Iron meets microprocessor

The Glitch

An old New England farm house has been heated with a two-pipe steam system serving plenty of study cast-iron radiators. As part of an extensive renovation and insulation upgrade, the owner decides to upgrade the heat and convert the system to a high-efficiency, gas-fired condensing boiler.

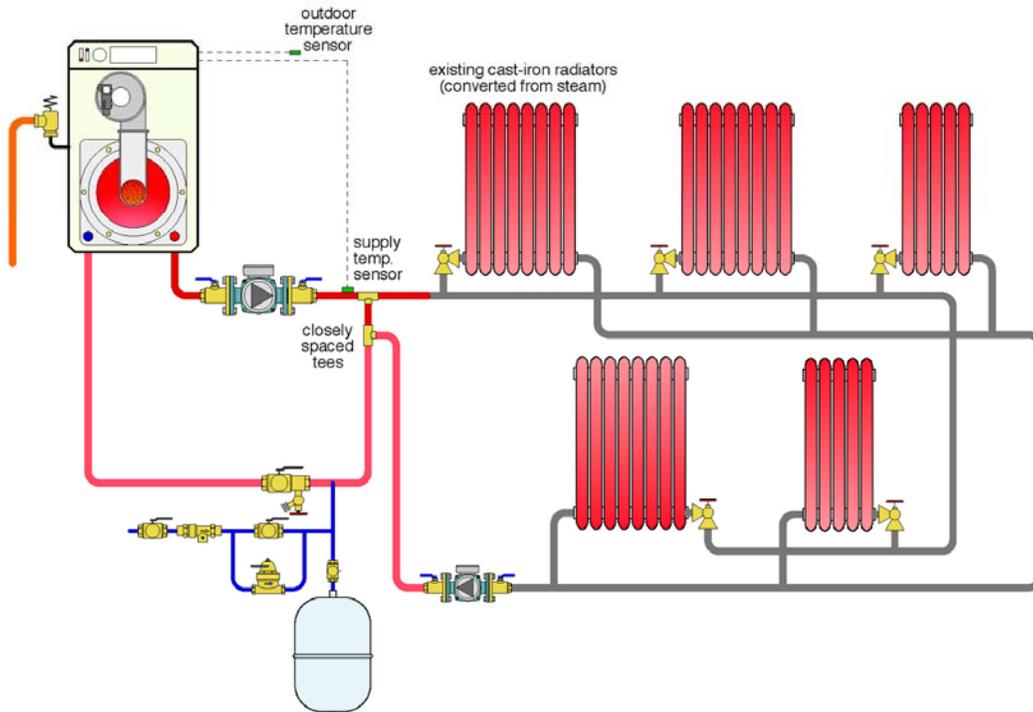
The owner is also complaining about the inability to adjust heat in different rooms. The piping system installed by the local plumber is shown below. It leaves as much of the two-pipe distribution in place as possible.

What are some design details that you think are incorrect or missing?

Other details that are incorrect in the original drawing include:

- The circulator in the boiler loop should be pumping into the condensing boiler (because the latter has a high flow-resistance heat exchanger).
- If you expect hydraulic separation between circuits, *do not* install closely spaced tees as shown in the Glitch drawing. Instead, provide a minimum of 6" pipe diameter of straight pipe both upstream and downstream of the closely spaced tees.

- There is no microbubble air separator in the system.
- The supply temperature sensor for the boiler should be downstream of the point of hydraulic separation between the boiler circuit and distribution circuit. This allows the boiler to react to any mixing taking place.

- The purging valve should be upstream of the makeup water connection.
- One circulator is at the low point of the distribution system — the most probable location for sediment to collect.

- There is no way to purge air from individual radiators.
- There is no effective way to purge the distribution circuit.

The Fix

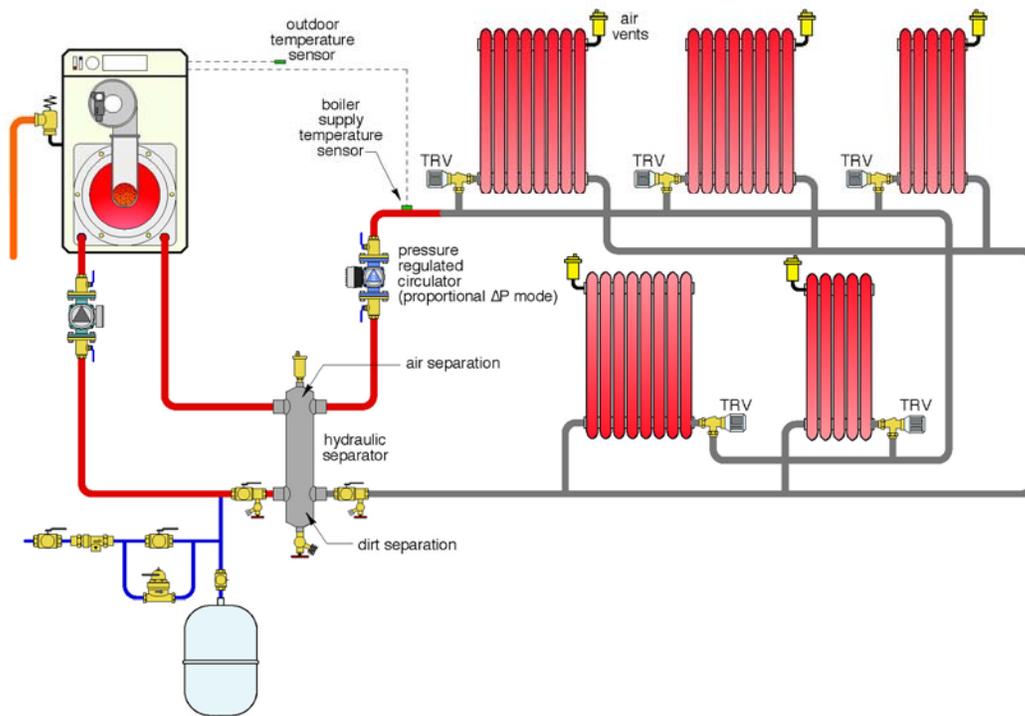
Over decades of use, lots of “crud” can built up in a steam heating system with cast-iron radiators. It’s really a shame to push that crud into new portions of the system and especially into the compact heat exchanger of the new boiler.

I’d recommend a hydraulic separator as an ideal way to connect the old iron portion of the system with the new components. It provides hydraulic separation between the boiler circulator and the variable-speed, pressure-regulated distribution circulator. It also provides high performance air separation and dirt separation.

The latter function is enhanced by placing the hydraulic separator as low as possible within the system. Be sure to leave room for a blow-down valve at the bottom because you are sure to be using it. Also be sure the flow velocity into the hydraulic separator is not more than 4 ft. per second.

The fix drawing also shows the use of wireless thermostatic radiator valves, rather than manually operated globe valves, at the inlet of each radiator. This effectively converts each radiator into its own zone and allows the owner to adjust the temperatures in different areas of the house as he wants. These valves are a perfect complement to the variable-speed, pressure-regulated circulator.
